Interactive comment on “Impacts of the emergency operation of the South-to-North Water Diversion Project’s eastern route on flooding and drainage in the water-receiving area: An empirical case from China” by Kun Wang et al.

Responses to Referee #2’ comments

Fig. 1.

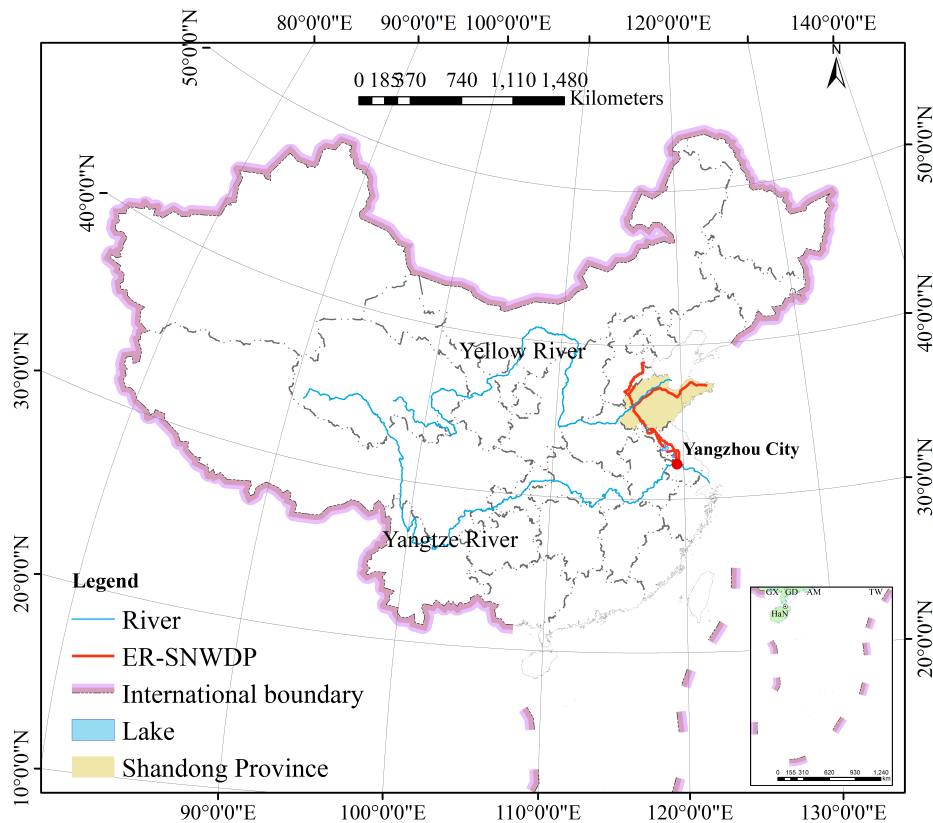
L28: a map showing the most important geographical places, including contour lines and information about elevations would be required. Furthermore, some climatic characterisations (annual rainfall as colourcode) would help understanding the general con-

Page 5 Fig. 1: Please add (a), (b) and (c) to the single figures, as it is usual. In the upper right map: why is China's SE not continuously bordered? What does the inset map express and why is the international border southwards dashed? In the upper left map: please name the rivers. In the lower map: please indicate the location of the dam, Description of Fig. 5: delete "The logo of Copernicus publications" L4: what is Yangzhou? L5-8: please indicate the location of sluices and dams in Fig.1, otherwise it is impossible to follow.

Answer: Fig.1 has been divided to Fig.1 (in section1) and Fig.2 (in section 2).The contour lines of annual rainfall has been added in Fig.1 b, and Surface elevation information of Nansi Lake basin has been added in Fig.2.

Answer: Those figures have been modified as these suggestions. We made a map of China according to the convention of Chinese map. Thank you for your suggestions.

Fig. 2.

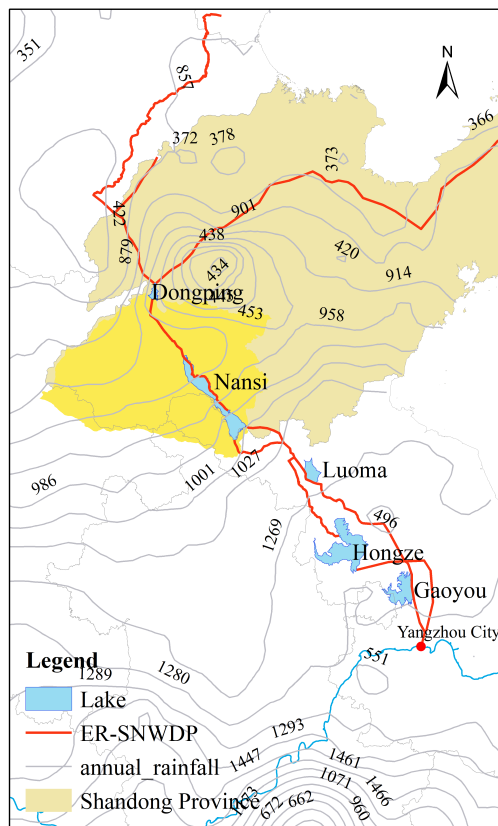
L29: development of what? L30: which lake and what does the lakeside area mean? It is somehow indicated in Fig. 1, but what are the borders, how are they defined, etc.

L9: river channel bathymetry of which river? L11: please indicate the location of rainfall stations in map of Fig. 1. L13: please indicate the location of water level recording stations in Fig. 1

L10: The information concerning the locations of the stations is missing to follow argumentation

Answer: The economic development in lake basins along the ER-SNWDP. The lakeside area refers to the area with ground elevation below 36.79 m around Nansi Lake (Fig.2). We explained it in the manuscript, and Fig.2 is modified. Tanks a lot.

Answer: The channel bathymetry of all rivers simulated in the 1-D model. The location of rainfall stations have been added in Fig.2. Thanks a lot.

Answer: The locations of the stations have been added to Fig.2. Tanks a lot.

Fig. 3.

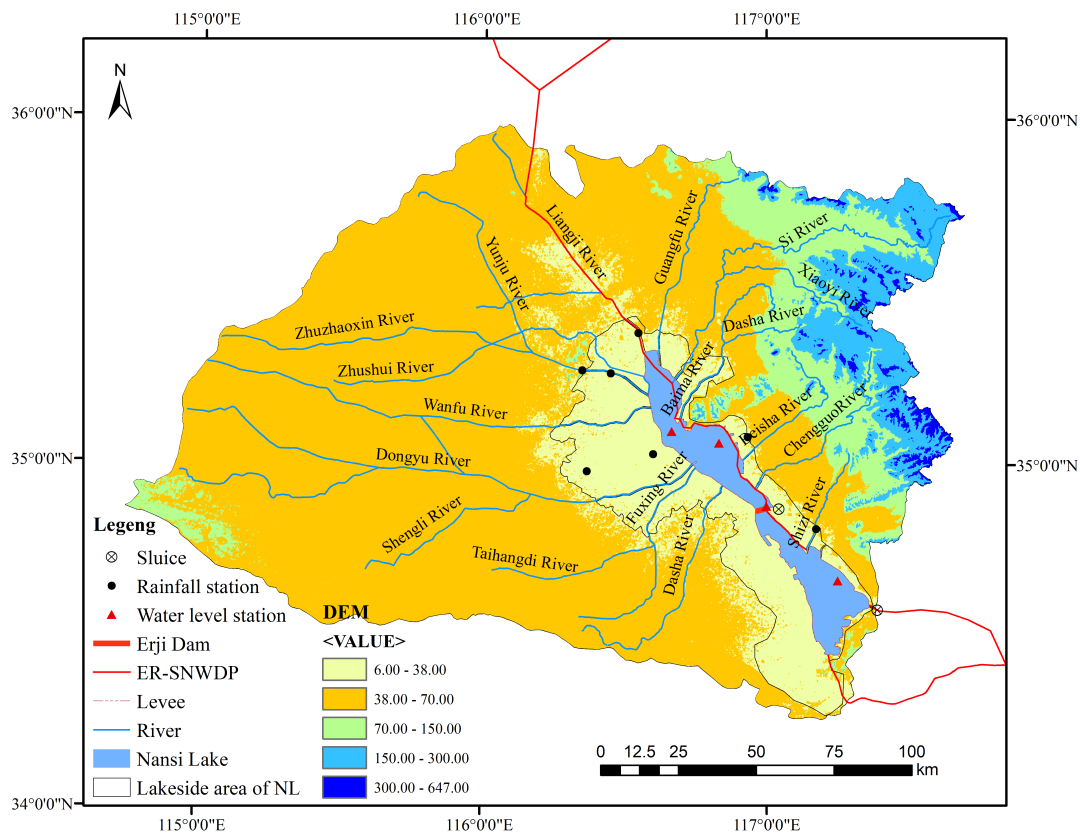
Page7 Fig. 2: where is MIKE FLOOD integrated into the workflow? L8-9: Equations are usually cited in the text.

Answer: The corresponding modification of Fig. 3 is made. And we revised the reference.
